**ADDENDUM:**

**STATE SIGNIFICANT  
DEVELOPMENT ASSESSMENT  
Warkworth Continuation Project  
(SSD-6464)**

Environmental Assessment Report  
Section 89E of the  
*Environmental Planning and Assessment Act 1979*  
May 2015

**Figure 1:** Measured low frequency noise spectra compared to modified DEFRA curve

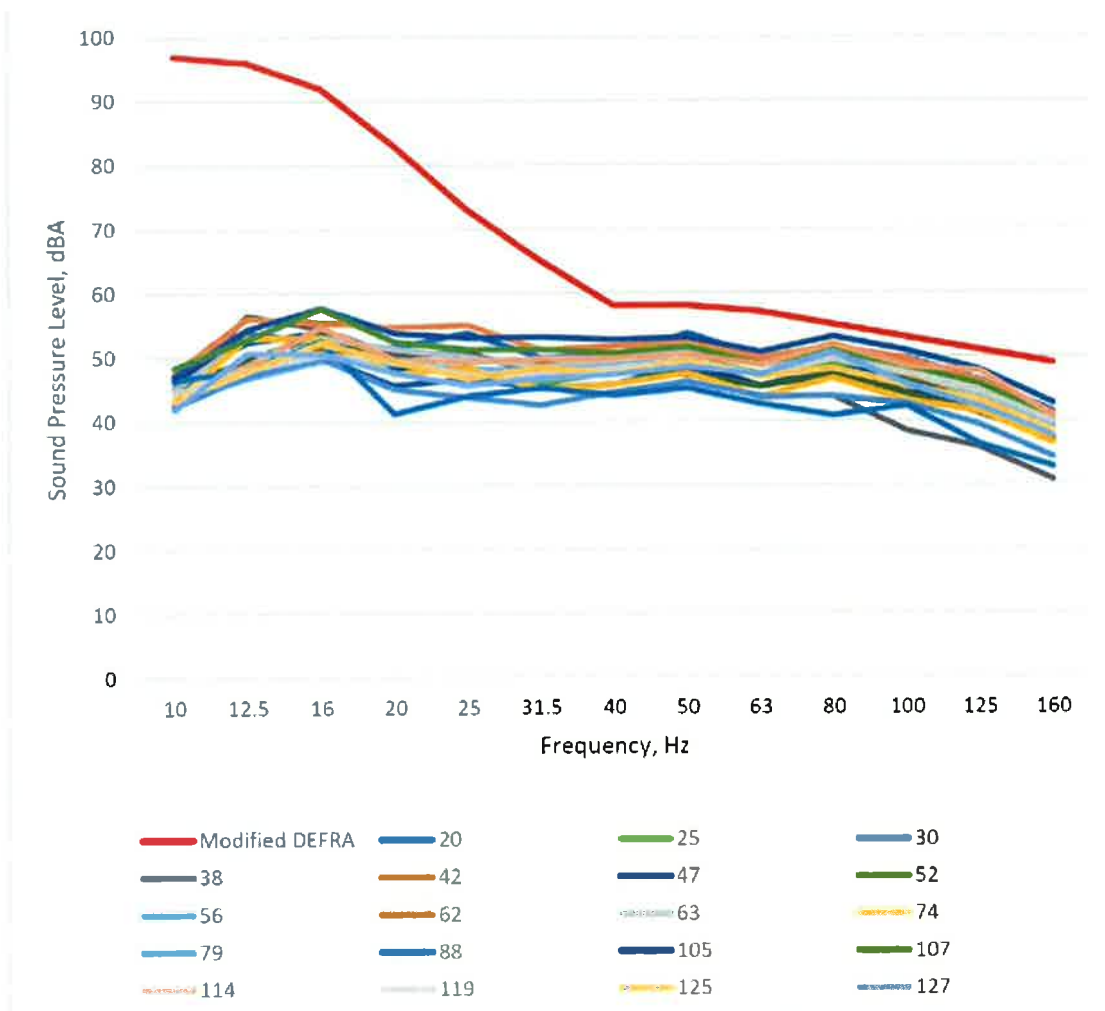
As mentioned above, the Department recently engaged specialist acoustic consultants Wilkinson Murray to undertake a 10 day noise audit of noise impacts in Bulga to further assess noise compliance (see Attachment E). The audit report includes LFN analysis using the C – A, Broner and DEFRA curve methods.

The audit indicates that C – A levels do exceed the 15dB threshold levels at all of the monitoring locations in Bulga Village. However, the LFN levels were found to comply with the modified<sup>4</sup> DEFRA curve thresholds at all receivers. An example of the monitoring results against the modified DEFRA curve at one of the key residences in Bulga is shown in Figure 1 below.

However, given the limitations of the current approach outlined under the INP, the Department has amended the recommended conditions (Appendix 7 of the conditions) to clarify that the modifying factor for LFN is to be applied, except where it can be demonstrated that this is only as a result of differential attenuation over distance.

Figure 2: Options for Partial Filling of Overburden Emplacements Gap

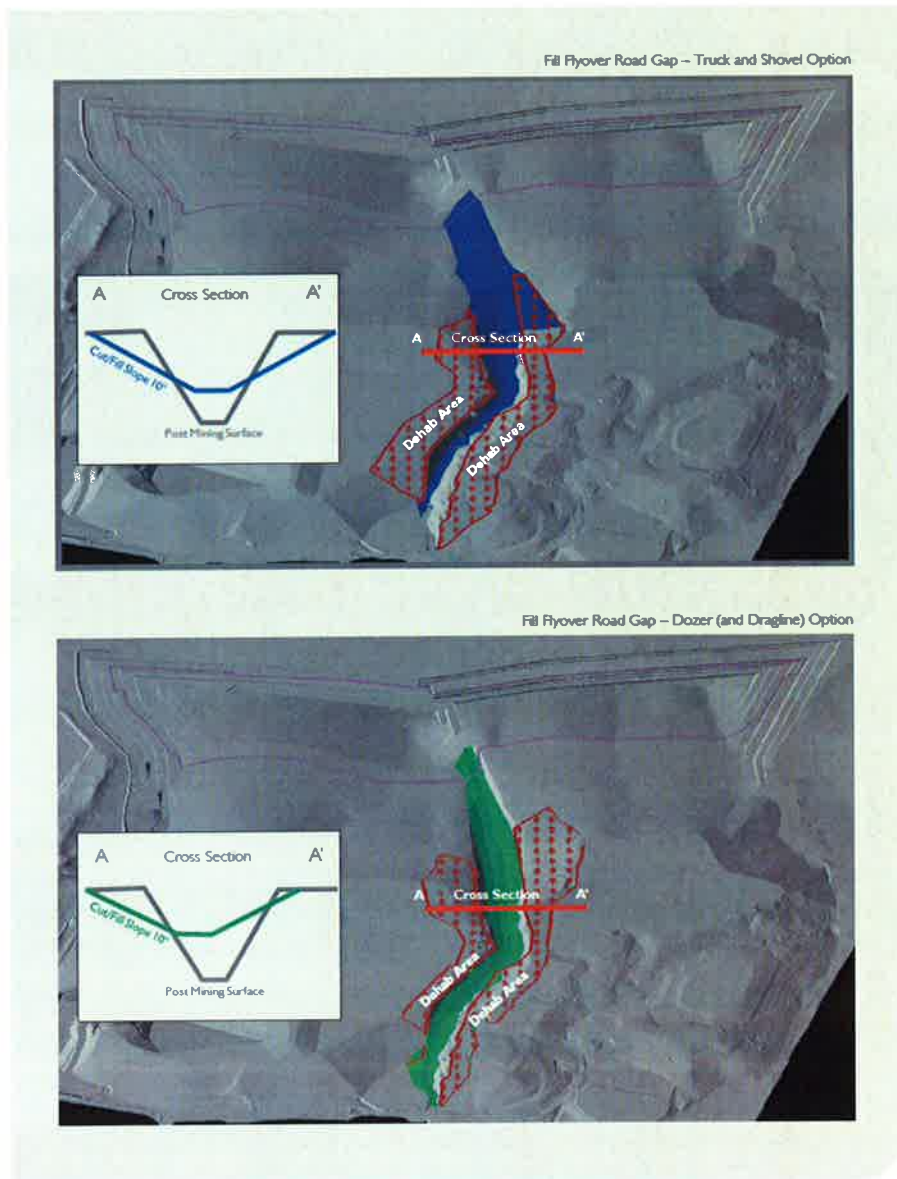
With regard to filling the gap between the two main overburden emplacements, Warkworth has considered two options for undertaking this work (with Option 1 using truck and shovel to undertake the work and Option 2 using a dozer – see Figure 2 below).

The options would result in relatively similar benefits, with Option 2 found to be considerably cheaper to implement and requiring less disturbance of rehabilitated areas. The Department has amended the recommended conditions to reflect this commitment (see condition 56 of schedule 3).
